FINAL PRODUCT/PROCESS CHANGE NOTIFICATION #16885Generic Copy

Issue Date: 27-Jul-2012**TITLE:** Qualification of Good-Ark Electronics for SMA/SMB Power Rectifier Products**PROPOSED FIRST SHIP DATE:** 27-Oct-2012**AFFECTED CHANGE CATEGORY(S):** Power Discrete Division (PDD) of the Standard Product Group**FOR ANY QUESTIONS CONCERNING THIS NOTIFICATION:**

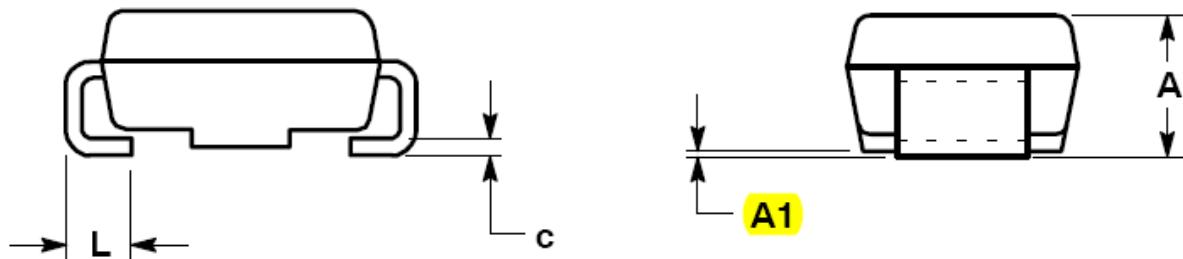
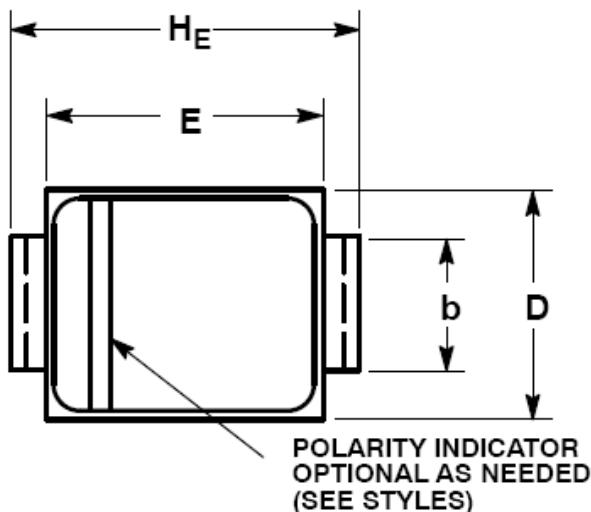
Product from Good-Ark Electronics will be identified by "g" site code marking.

SMB

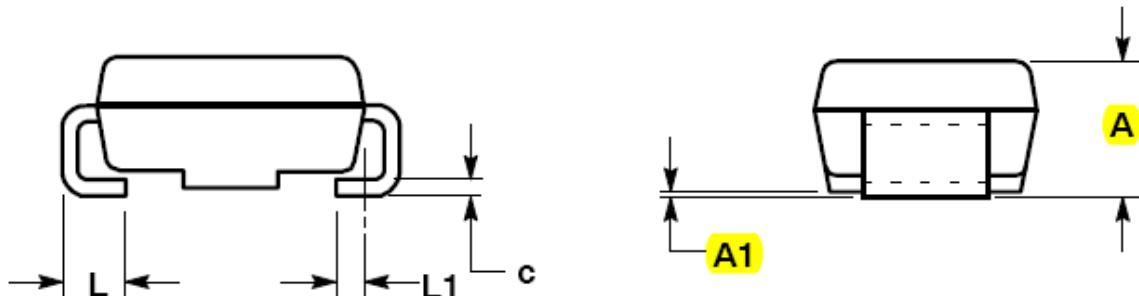
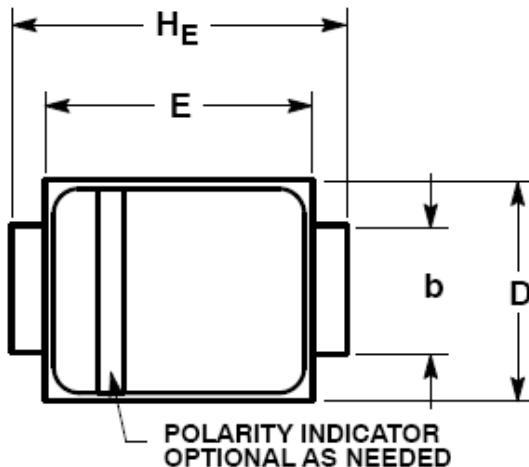
FINAL PRODUCT/PROCESS CHANGE NOTIFICATION #16885

1. DIMENSIONING AND TOLERANCING PER ANSI Y14.5M, 1982.
2. CONTROLLING DIMENSION: INCH.
3. DIMENSION b SHALL BE MEASURED WITHIN DIMENSION L1.

DIM	MILLIMETERS			INCHES		
	MIN	NOM	MAX	MIN	NOM	MAX
A	1.95	2.30	2.47	0.077	0.091	0.097
A1	0.05	0.10	0.20	0.002	0.004	0.008
b	1.96	2.03	2.20	0.077	0.080	0.087
c	0.15	0.23	0.31	0.006	0.009	0.012
D	3.30	3.56	3.95	0.130	0.140	0.156
E	4.06	4.32	4.60	0.160	0.170	0.181
H_E	5.21	5.44	5.60	0.205	0.214	0.220
L	0.76	1.02	1.60	0.030	0.040	0.063
L1	0.51 REF			0.020 REF
